TC-366

SERVICE MANUAL

SUBJECT: PRODUCTION CHANGE OF POWER SUPPLY CIRCUIT BOARD
APPLICABLE SERIAL NO.: 37,171 and later (GENERAL EXPORT MODEL)
35,261 and later (USA MODEL)

SUBJECT: PRODUCTION CHANGE

Fig. 1 Transistor change

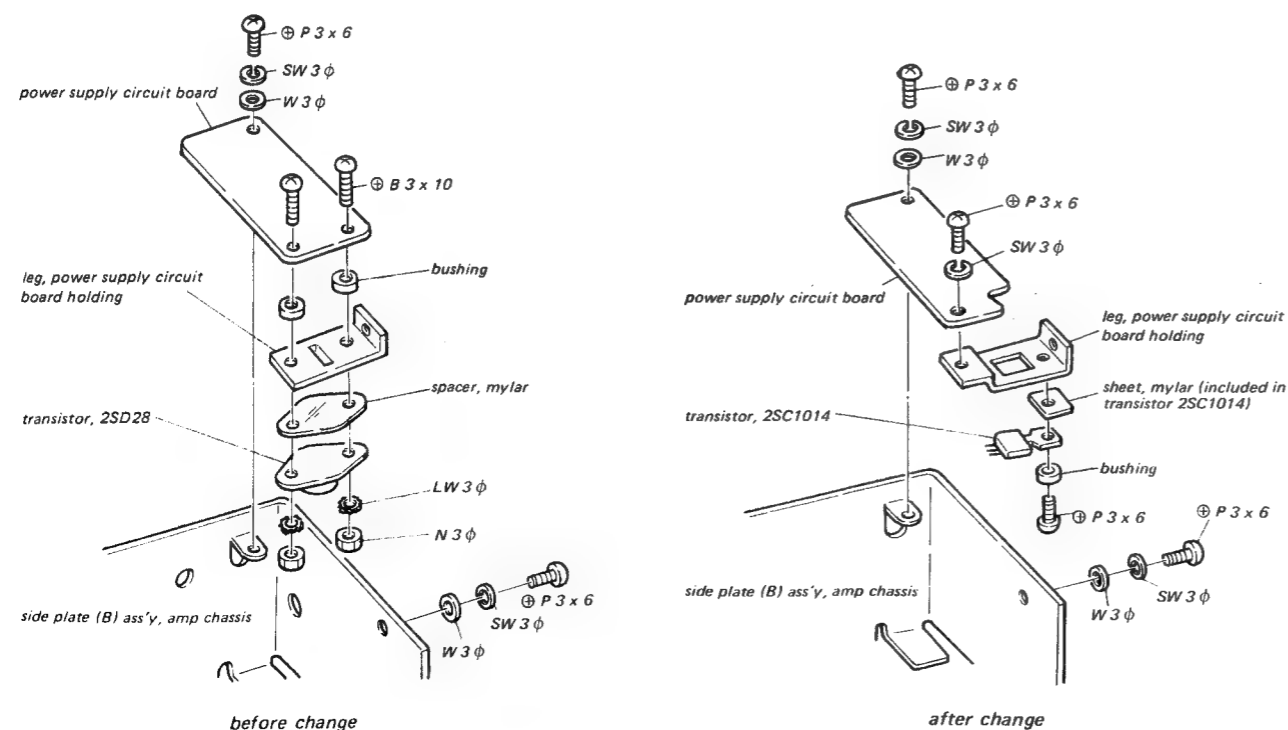
Description	Former	New
leg, power supply circuit board holding	3-472-230	3-472-308

Fig. 2 Schematic diagram

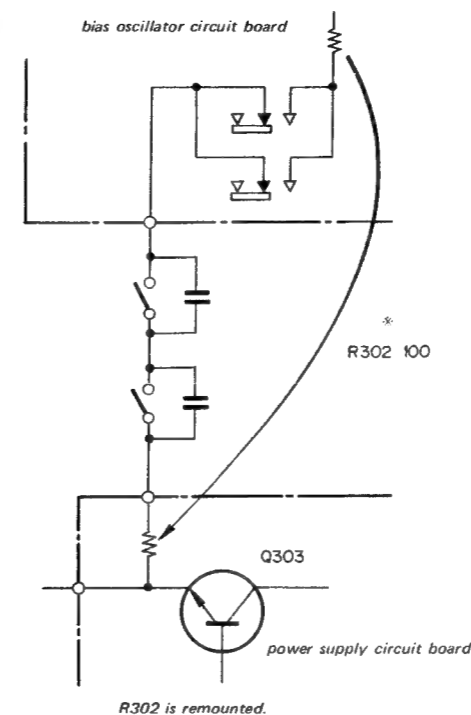
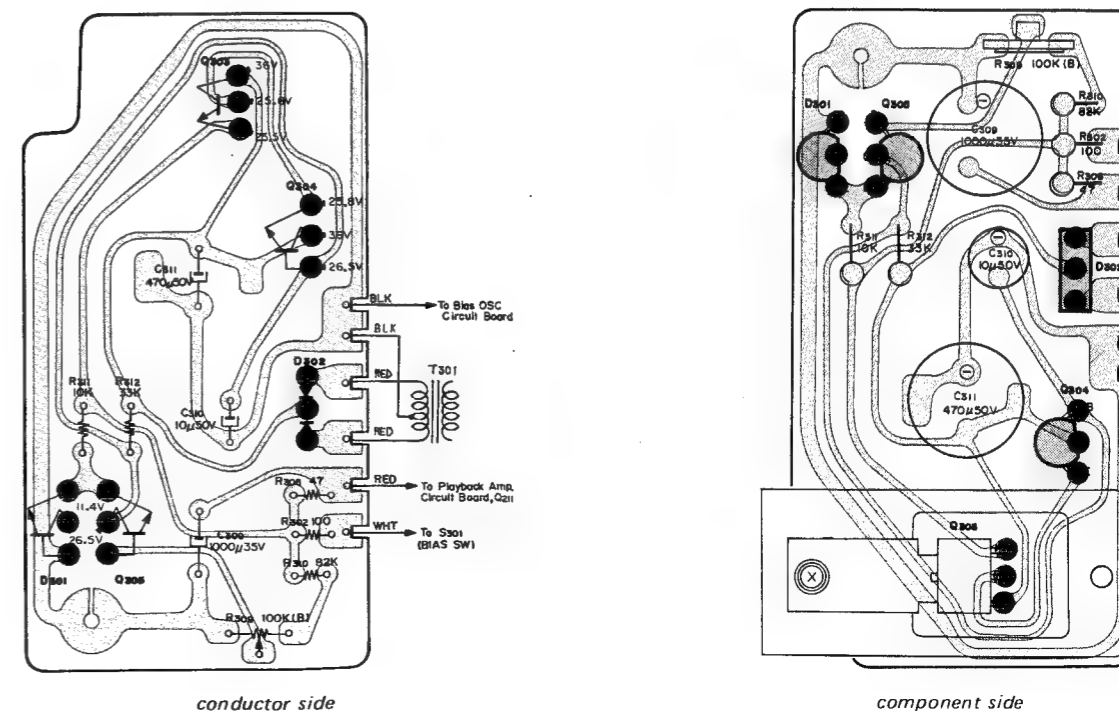
2. R302 (100Ω) is remounted on the power supply circuit board from the bias oscillator circuit board, to prevent Q304 from damage caused when B+ circuit of the bias oscillator board is short-circuited. See Figs. 2 and 3.

Fig. 2-5 Tape slack check

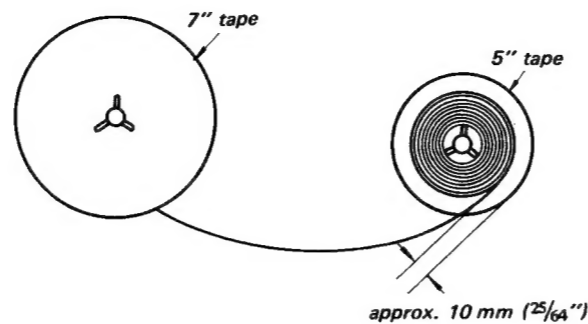
After the brake adjustment, thread a tape on the machine as shown in Fig. 2-5. Make sure that the tape does not slack when changing a mode from the FF to the STOP and also from the STOP to the REC.

Fig. 2-6 Instant stop adjustment

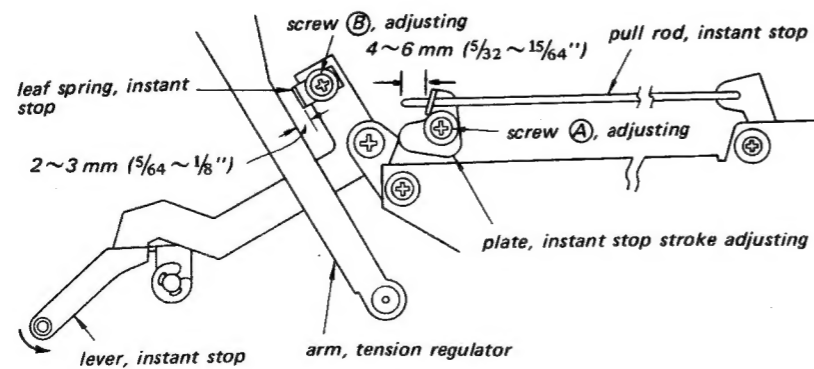
- ① Make sure that the tension regulator adjustment has been made.
- ② Adjust the screw ㉖ so that the distance between the end of the instant stop pull rod and the instant stop stroke adjusting plate is 4 to 6 mm ($\frac{5}{32}$ to $\frac{15}{64}$ ").
- ③ Be sure that the clearance between the pinch roller and the capstan is more than 1 mm ($\frac{3}{64}$ ") when pulling the instant stop lever in the FWD mode, and that the instant stop knob is not locked when pulling it in the STOP mode.
- ④ Adjust the screw ㉗ so that the clearance between the tension regulator arm and the instant stop leaf spring is 2 to 3 mm ($\frac{5}{64}$ to $\frac{1}{8}$ ") in the STOP mode.
- ⑤ Apply lock paint to the screws.

Fig. 1 Tension regulator drum assembly

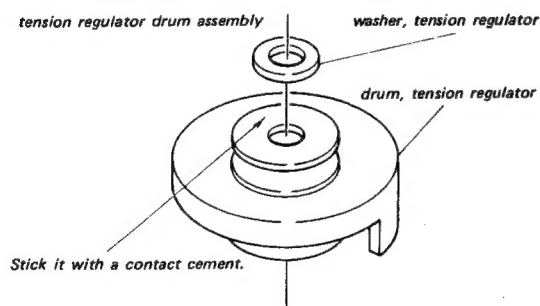
Description	Part No.
Former	drum, tension regulator	3-472-163-00
New	drum ass'y, tension regulator (including drum, tension regulator felt, tension regulator)	X-34721-07 (3-472-163-02) 3-472-320

Fig. 2 Tension regulator drum installation

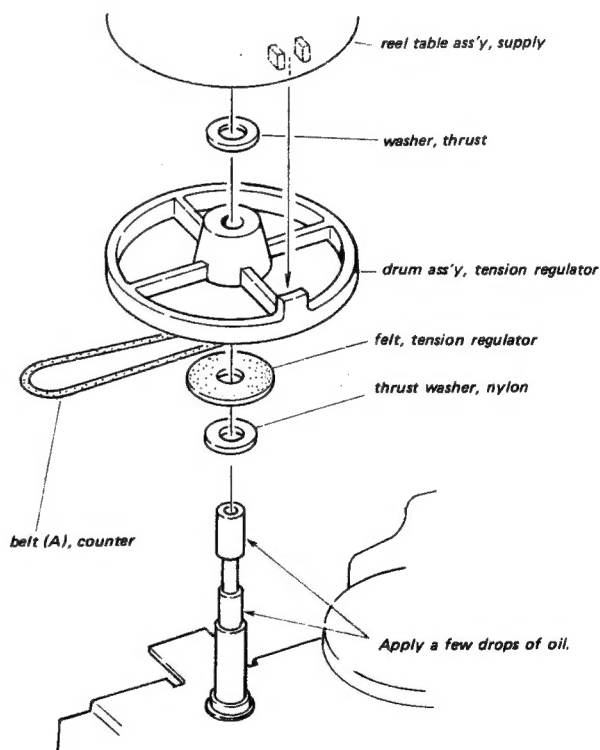
1. Between the tension regulator drum and the table base plate assembly, put in a nylon washer with grease applied.
2. Apply a few drops of oil to the reel shaft.

Fig. 1 Transistor change

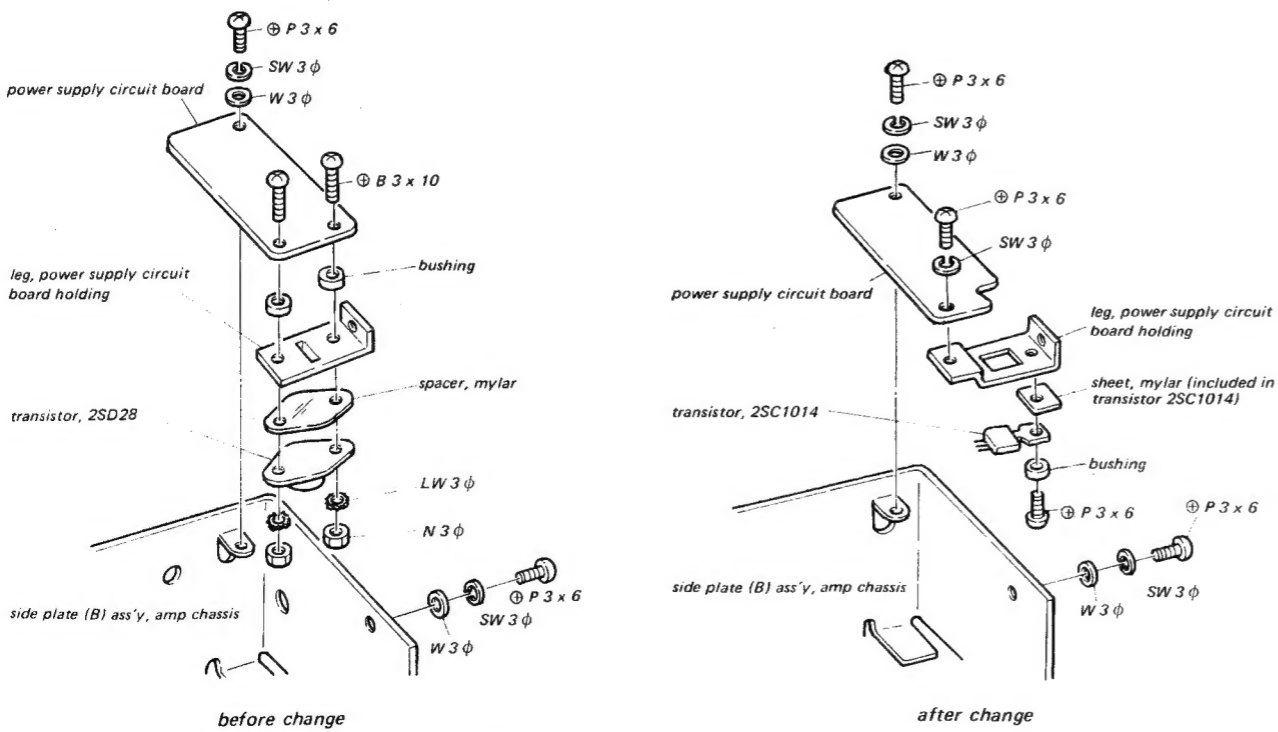
SUBJECT: PRODUCTION CHANGE OF POWER SUPPLY CIRCUIT BOARD
APPLICABLE SERIAL NO.: 37,171 and later (GENERAL EXPORT MODEL)
35,261 and later (USA MODEL)

Description	Former	New
leg, power supply circuit board holding	3-472-230	3-472-308

Fig. 2 Schematic diagram

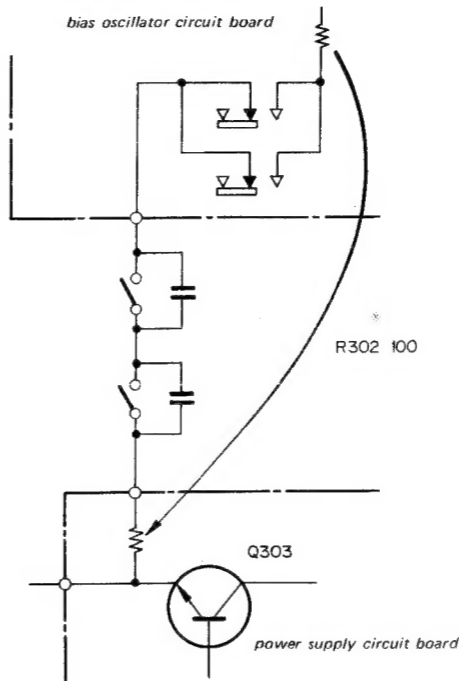
2. R302 (100Ω) is remounted on the power supply circuit board from the bias oscillator circuit board, to prevent Q304 from damage caused when B+ circuit of the bias oscillator board is short-circuited. See Figs. 2 and 3.
